Access Compliance Report

Public Rights-of-Way

Intersection ID: 52622	Main Street: HERITAGE_POND_DR	Cross Street: ALEXANDER_COMMONS_DR	Location:	E
ADA ID: 3BA5383578D6	Ramp Type: Perp	Initial Pass/Fail: Fail	Overall Compliance: No	Severity Score: 25
Codes/Mitigation Info/Possible Solution		Field Measurements/Component Compliance

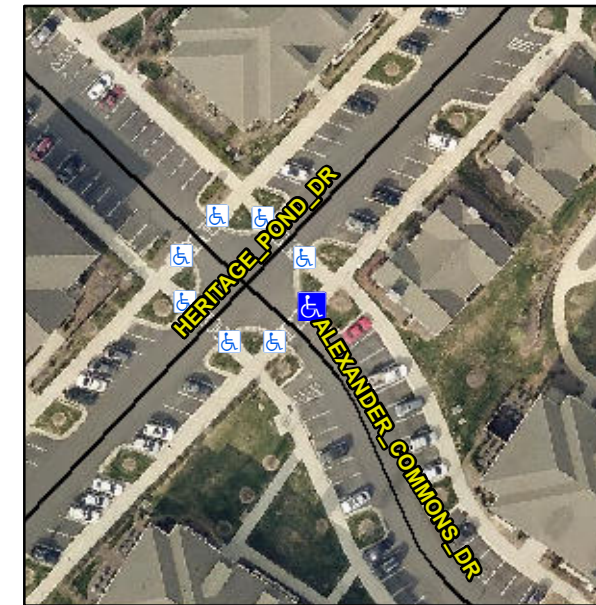
R304.2.2

Compliance	Description	Data	Compliance	Description	Data
N/A	Ramp Length (in)	95.5	No	Ramp Slope (%)	15.7
Yes	Ramp Width (in)	99.5	Yes	Ramp XSlope (%)	0.2
N/A	Flare Type LT	N/A	N/A	Flare Type RT	N/A
N/A	Flare Slope LT (%)	N/A	N/A	Flare Slope RT (%)	N/A
N/A	Flare Traversable LT?	N/A	N/A	Flare Traversable RT?	N/A
N/A	Landing Length (in)	N/A	N/A	DWS Provided?	N/A
N/A	Landing Width (in)	N/A	N/A	DWS Contrast?	N/A
N/A	Landing Slope (%)	N/A	N/A	DWS Length (in)	N/A
N/A	Landing X Slope (%)	N/A	N/A	DWS Full Width?	N/A
N/A	Landing Curb? (Y/N)	N/A	N/A	DWS Offset (in)	N/A
N/A	Shared Landing?	N/A			
N/A	Gutter Ponding?	N/A	N/A	Gutter Slope (%)	N/A
N/A	Gutter Lip Ht (in)	N/A	N/A	Gutter X Slope (%)	N/A
N/A	Painted X Walk1?	Yes	N/A	Painted X Walk2?	N/A
	X Walk 1 Direction	To SW		X Walk 2 Direction	N/A
N/A	X Walk 1 Width (in)	91.5	N/A	X Walk 2 Width (in)	N/A
	X Walk 1 Slope (%)	3.0		X Walk 2 Slope (%)	N/A
	X Walk 1 X Slope (%)	1.7		X Walk 2 X Slope (%)	N/A

Remove & Replace Entire Ramp.
